Regulation No. 86 (Installation of lighting and light-signalling devices for agricultural tractors)

Proposal for 01 Series of amendments to Regulation No. 86 (Installation of lighting and light-signalling devices for agricultural vehicles)

Submitted by the Chairs of the Informal Working Group on Agricultural Vehicles Lighting Installation*

Model A
(See paragraph 4.4. of this Regulation)

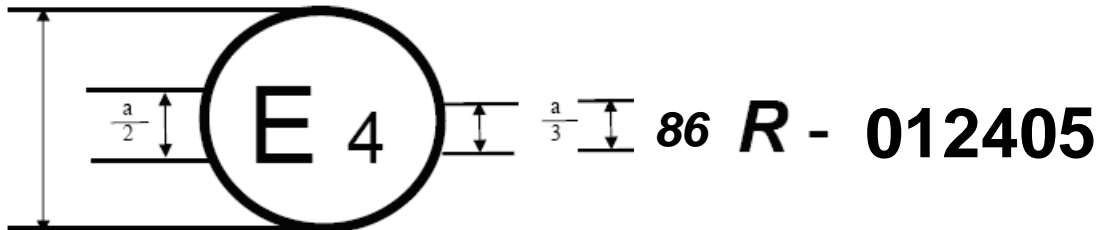
The above approval mark affixed to an agricultural or forestry vehicle shows that the vehicle type concerned has, with regard to the installation of lighting and light-signalling devices, been approved in the Netherlands (E 4) pursuant to Regulation No. 86. The approval number indicates that the approval was granted in accordance with the requirements of Regulation No. 86 ~~in its original form~~ **as amended by the 01 series of amendments.**

Model B
(See paragraph 4.5. of this Regulation)

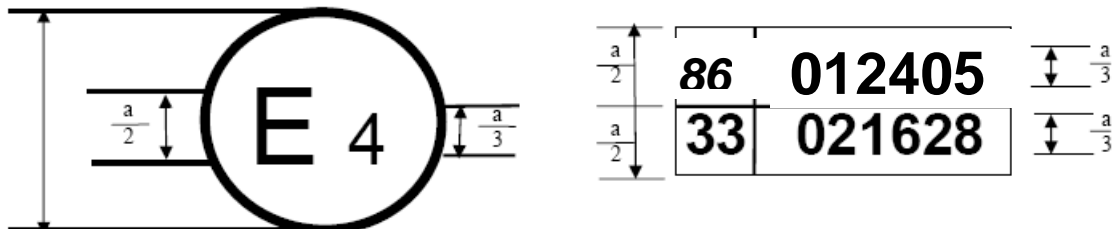
The above approval mark affixed to an agricultural or forestry vehicle shows that the vehicle type concerned has been approved in the Netherlands (E 4) pursuant to Regulations Nos. 86 and 33*. The approval numbers indicate that, at the dates when the respective approvals were given, Regulation No. 86 was ~~in its original form~~ **as amended by the 01 series of amendments** and Regulation No. 33 already included the 02 series of amendments.

Direction-indicator lamps - Geometric visibility

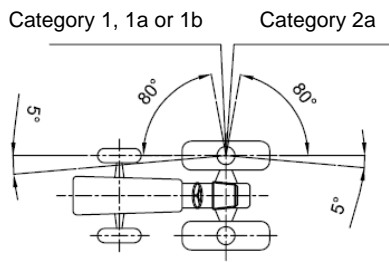
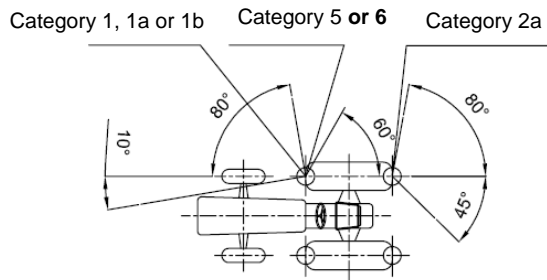
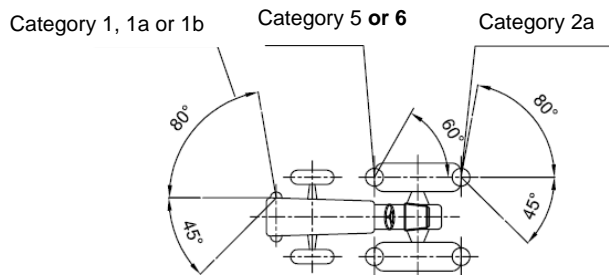
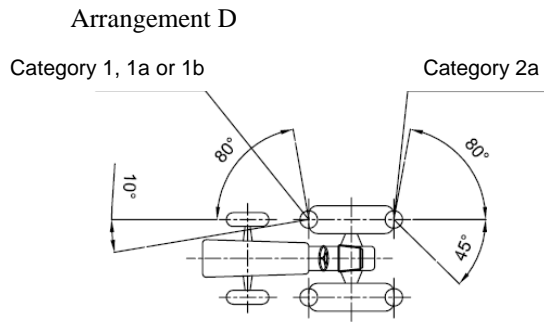
For rear direction indicators, the horizontal inward angle may be reduced to 30° if the shape of the bodywork makes it impossible to reach 45°.
